ENGINEERING ASSESSMENT AND DESIGN REPORT

**Lot 2 136 State Highway 26,
Hamilton**

PROJECT NO. 11122

Resource Consent Application – Further information request

Slope model failure arcs with FOS<1.5 shown for ILS SLS Case

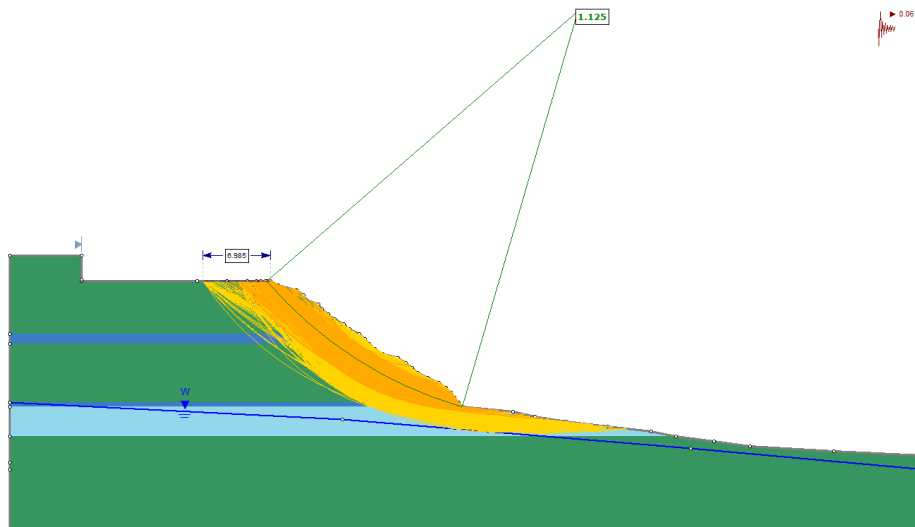
5. Please confirm whether the rainwater and wastewater treatment tanks are at potential risk of slope instability. While they lie beyond the 6m gully hazard set back, this does not translate directly into no risk of instability beyond this line.

- We confirm that the septic and rainwater tanks are setback 7.0m from the top of slope, as per the slope stability modelling under gravity and SLS conditions (IL1) the slope is considered stable.

As below the SLS case provides the critical setback requirement.

APPENDIX A - Proposed Site Layout Plan

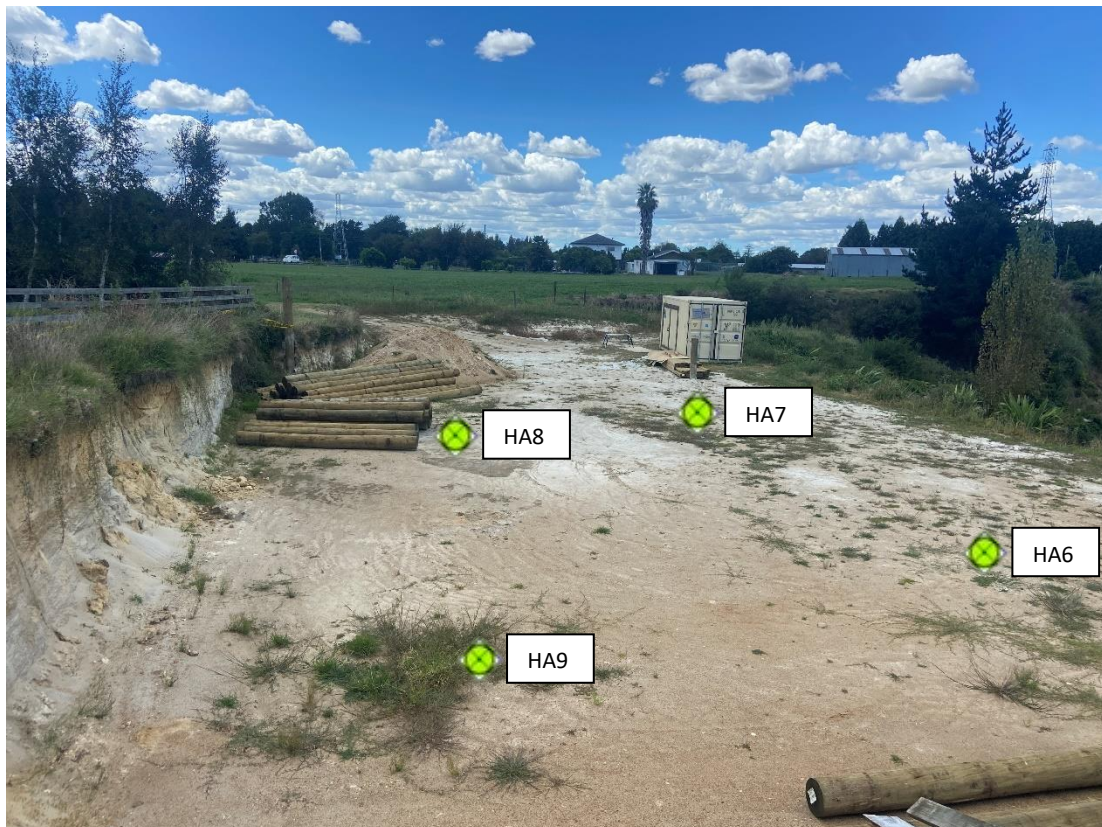
3. Please provide a site plan which includes appropriate referencing to the CPT data (i.e. number the CPTs for cross referencing purposes).
 - The CPTs have been numbered - refer to Appendix A

PROPOSED DWELLING (modelled on the 25/02/2022)

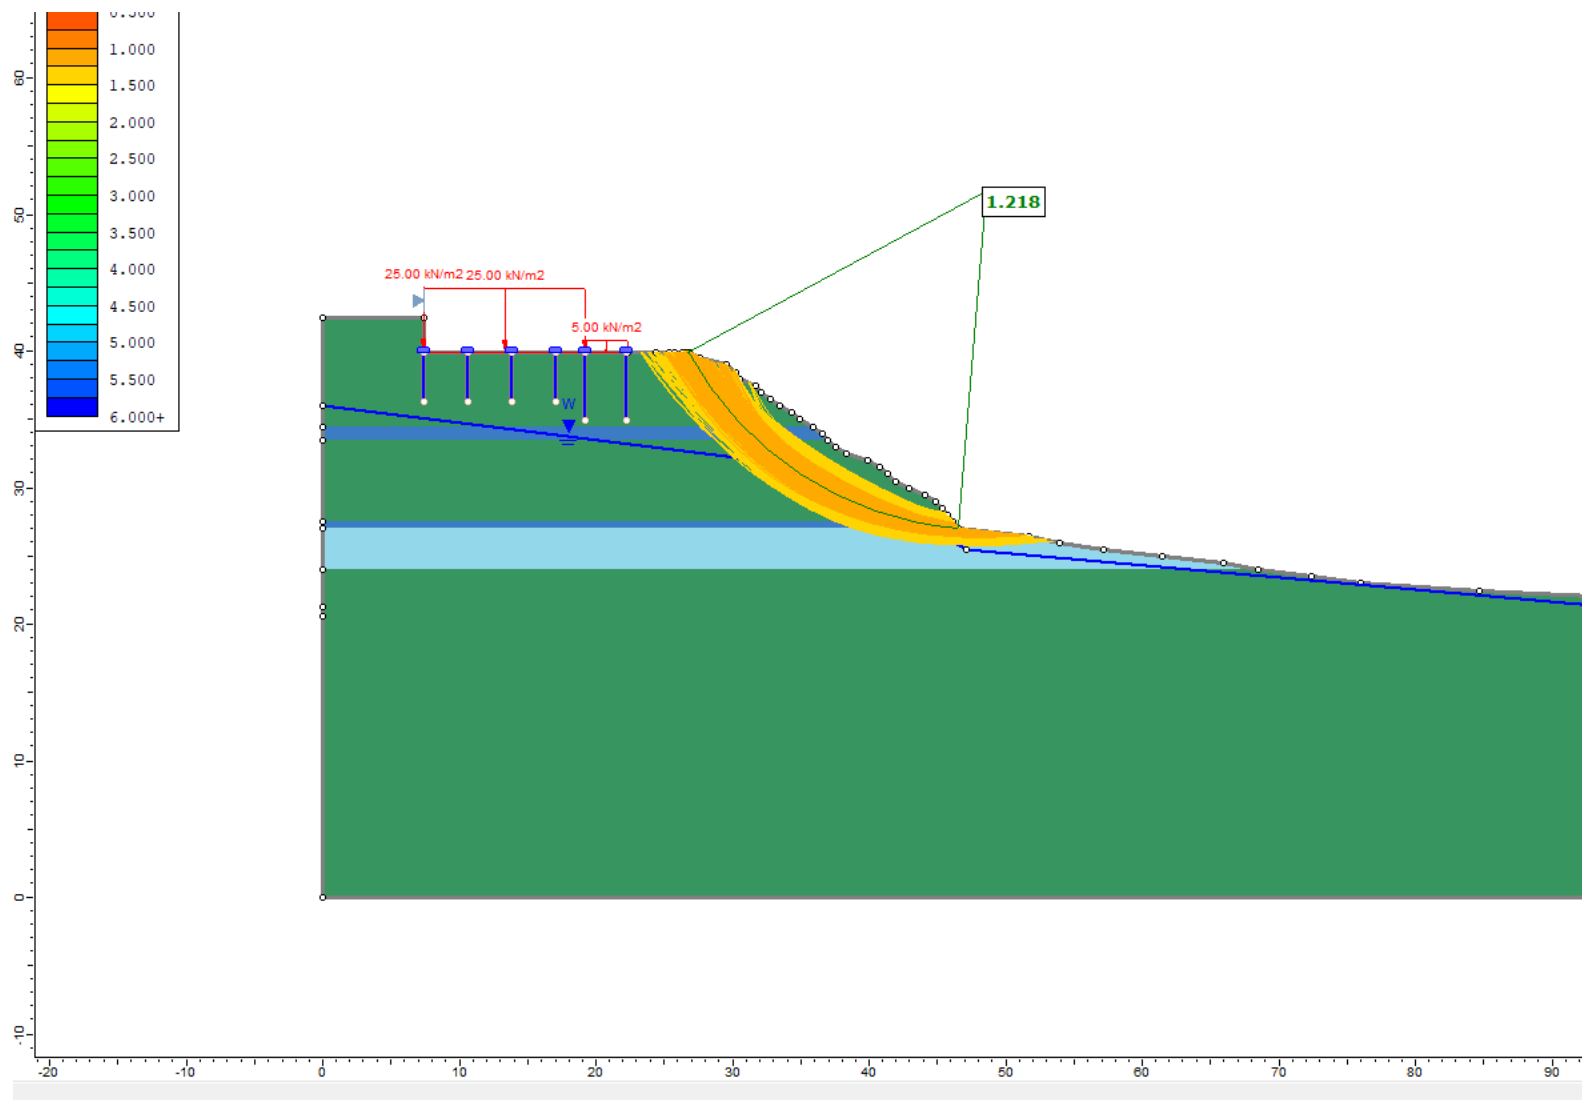
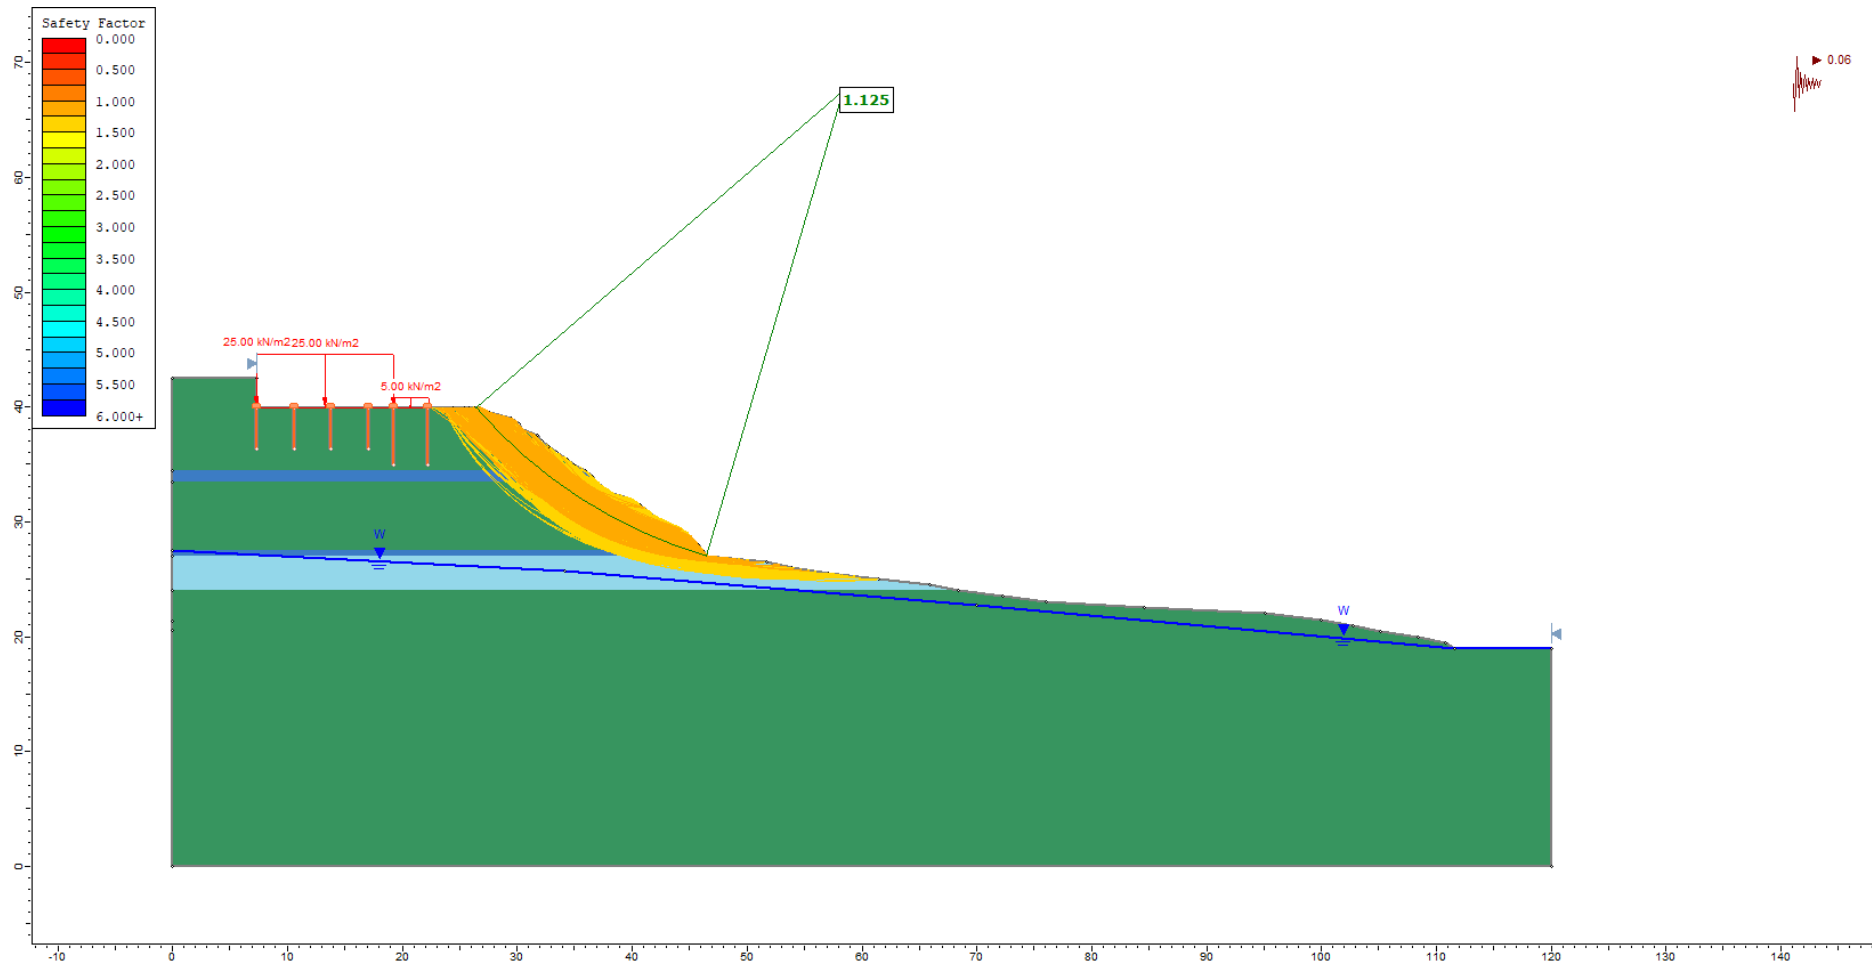
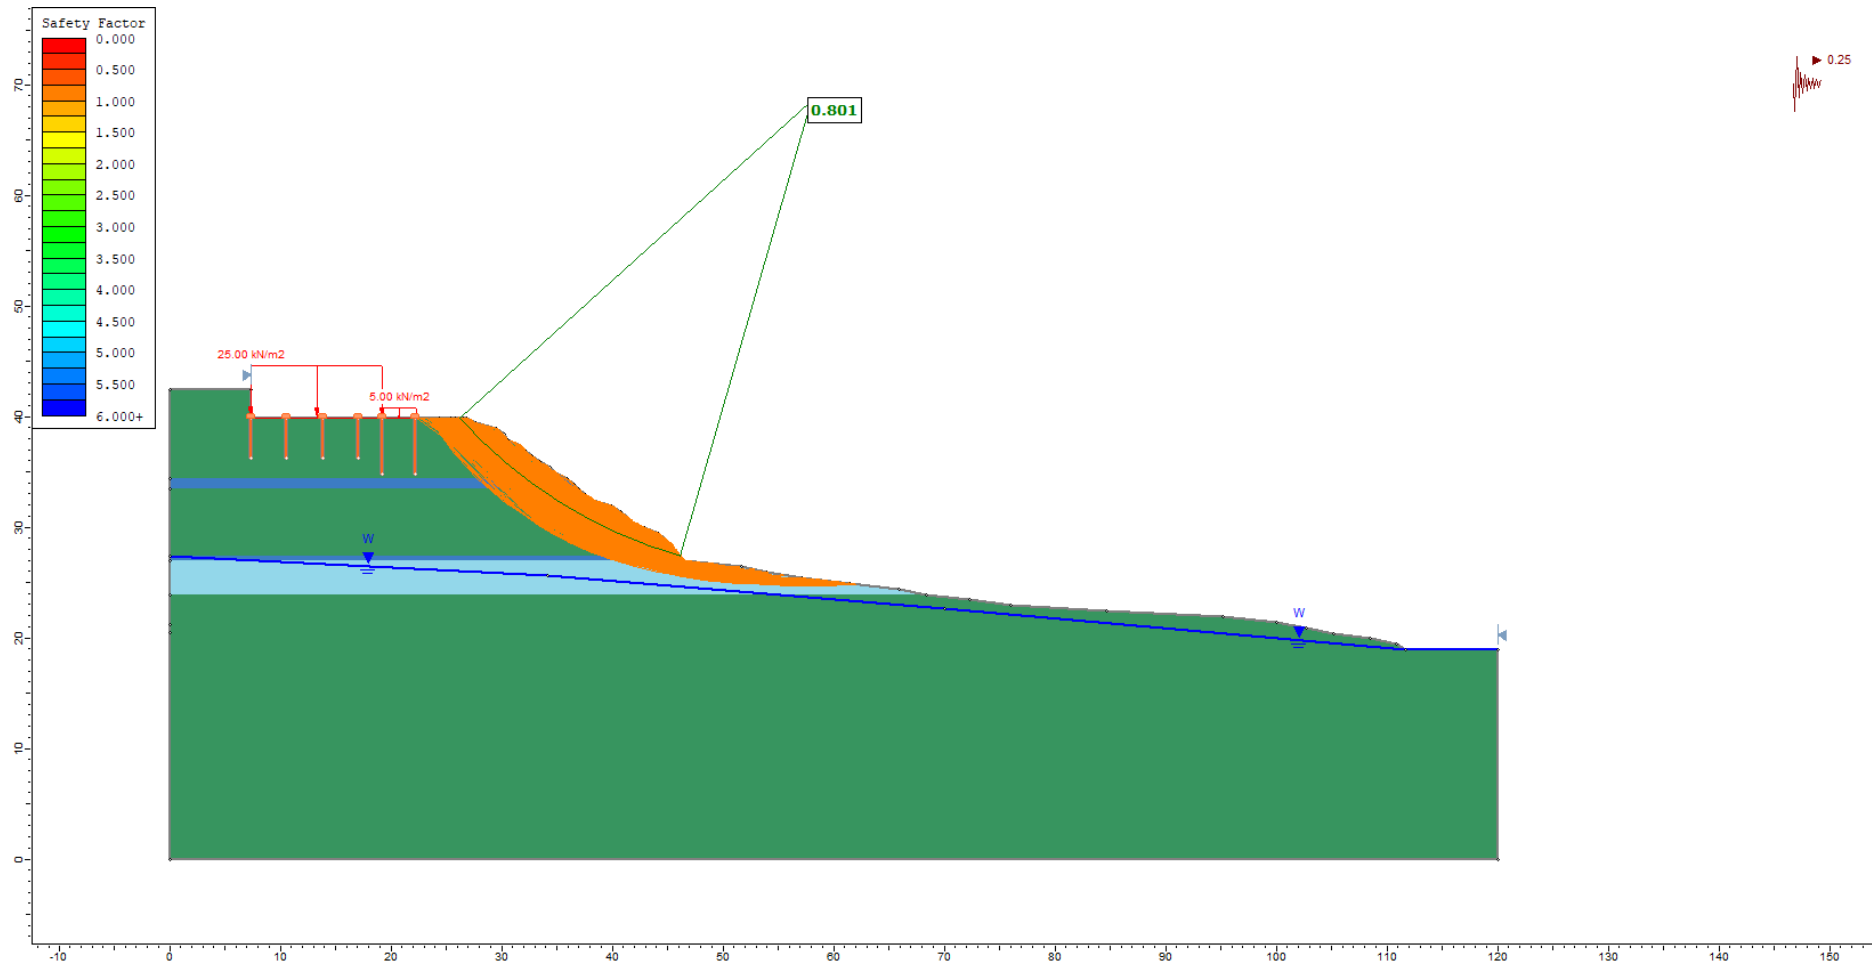
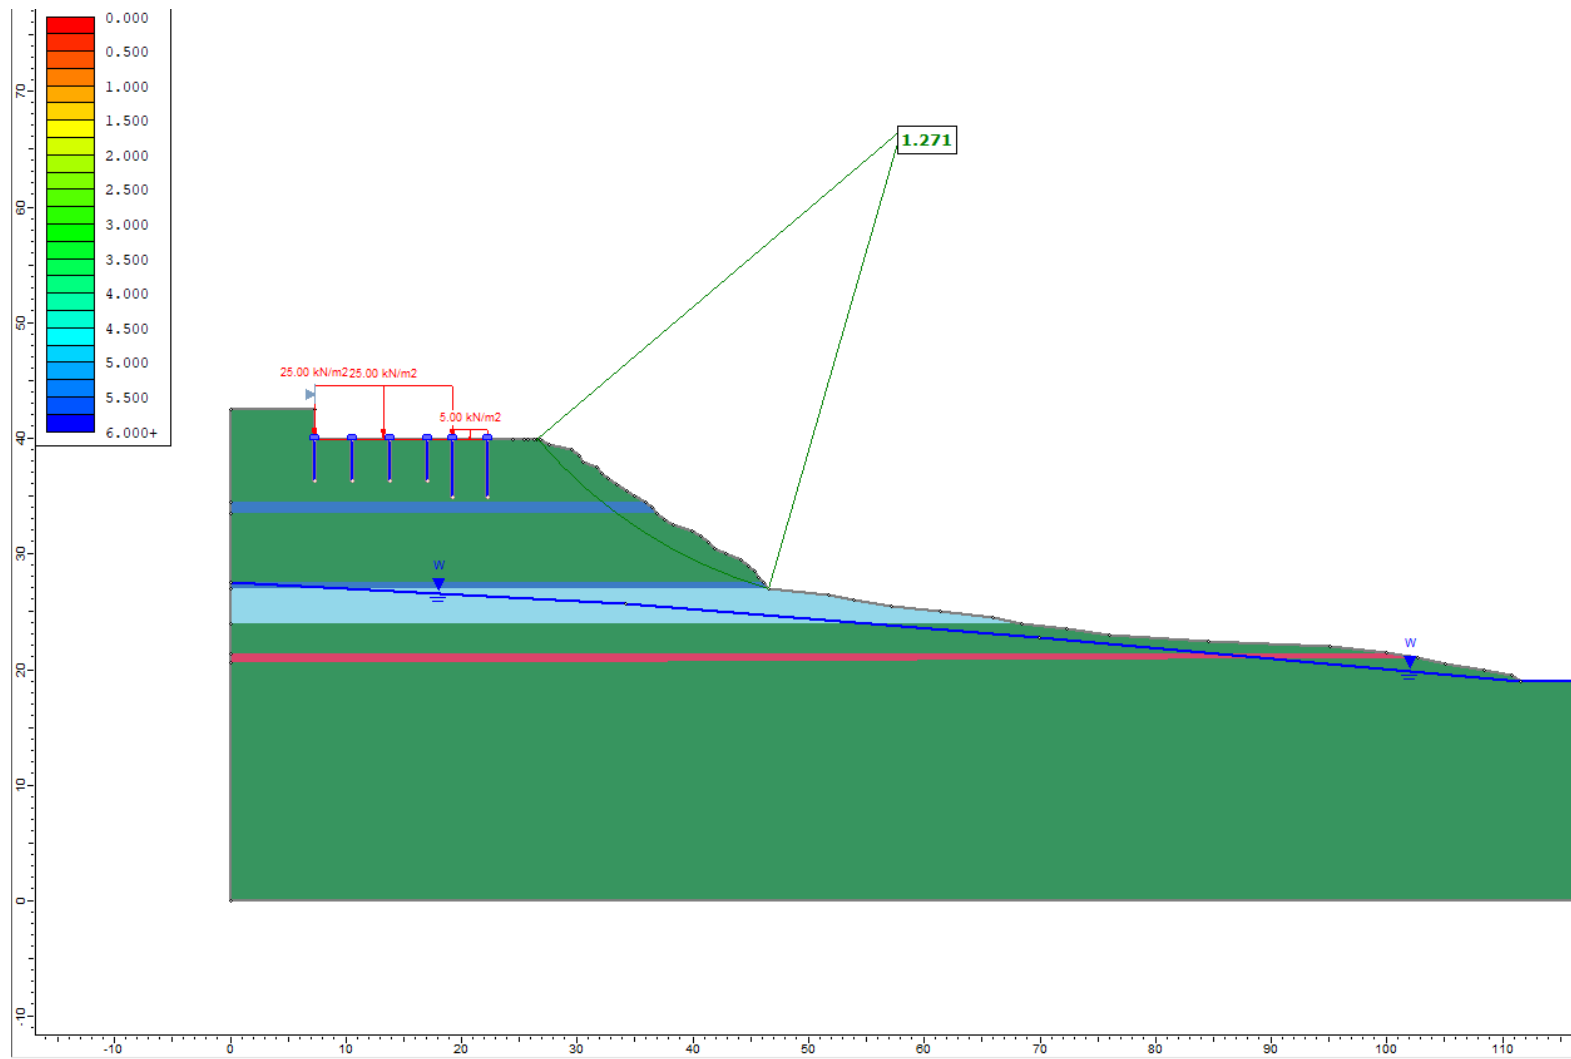
2. The slope stability assessment and liquefaction analysis has adopted peak ground accelerations which have been superseded in November 2021 update of MBIE Module 1. Please revise accordingly using the updated values provided by MBIE.

- The slope stability and liquefaction assessments have been updated to adopt the new MBIE peak ground accelerations. There was no change in terms of liquefaction risk. In terms of slope stability, the new seismic values have been adopted and modelled on the proposed dwelling slope stability model. The existing piling that is proposed for the site is sufficient to mitigate any changes due to the change in seismic values. Refer to Appendix I for updated liquefaction results and Appendix J (Proposed dwelling) for updated slope stability model.
